Access Compliance Report

Public Rights-of-Way

(Curb Ramps)

Intersection ID: 49297	Main Street: CAMPBELL_HALL_CT	Cross Street: CHAMBERLIN_RD	Location: SE
ADA ID: 71913B524D9A	Ramp Type: Perp	Initial Pass/Fail: Fail	Overall Compliance: No
Severity Score: 33.75			
Codes/Mitigation Info/Possible Solution		Field Measurements/Component Compliance

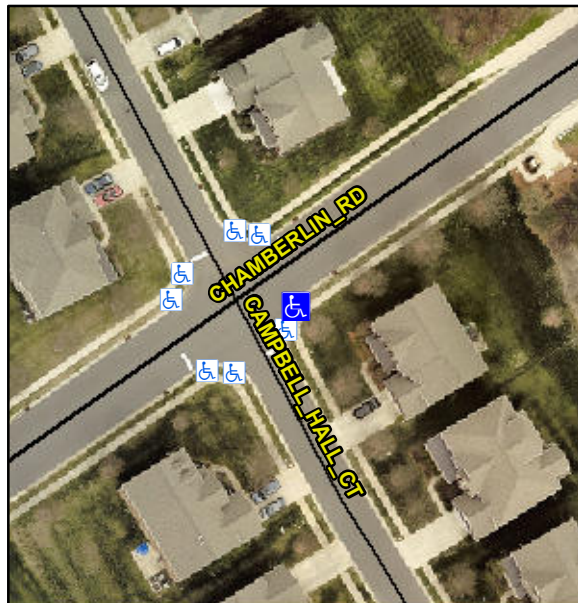
Not Found, R304.5.1, R304.2.2

Compliance	Description	Data	Compliance	Description	Data
N/A	Ramp Length (in)	48.0	No	Ramp Slope (%)	16.7
No	Ramp Width (in)	47.0	Yes	Ramp XSlope (%)	0.9
N/A	Flare Type LT	N/A	N/A	Flare Type RT	N/A
N/A	Flare Slope LT (%)	N/A	N/A	Flare Slope RT (%)	N/A
N/A	Flare Traversable LT?	N/A	N/A	Flare Traversable RT?	N/A
N/A	Landing Length (in)	N/A	N/A	DWS Provided?	N/A
N/A	Landing Width (in)	N/A	N/A	DWS Contrast?	N/A
N/A	Landing Slope (%)	N/A	N/A	DWS Length (in)	N/A
N/A	Landing X Slope (%)	N/A	N/A	DWS Full Width?	N/A
N/A	Landing Curb? (Y/N)	N/A	N/A	DWS Offset (in)	N/A
N/A	Shared Landing?	N/A			
N/A	Gutter Ponding?	N/A	N/A	Gutter Slope (%)	N/A
N/A	Gutter Lip Ht (in)	N/A	N/A	Gutter X Slope (%)	N/A
N/A	Painted X Walk1?	No	N/A	Painted X Walk2?	N/A
	X Walk 1 Direction	To NW		X Walk 2 Direction	N/A
N/A	X Walk 1 Width (in)	N/A	N/A	X Walk 2 Width (in)	N/A
	X Walk 1 Slope (%)	1.8		X Walk 2 Slope (%)	N/A
	X Walk 1 X Slope (%)	0.4		X Walk 2 X Slope (%)	N/A

Remove & Replace Entire Ramp.
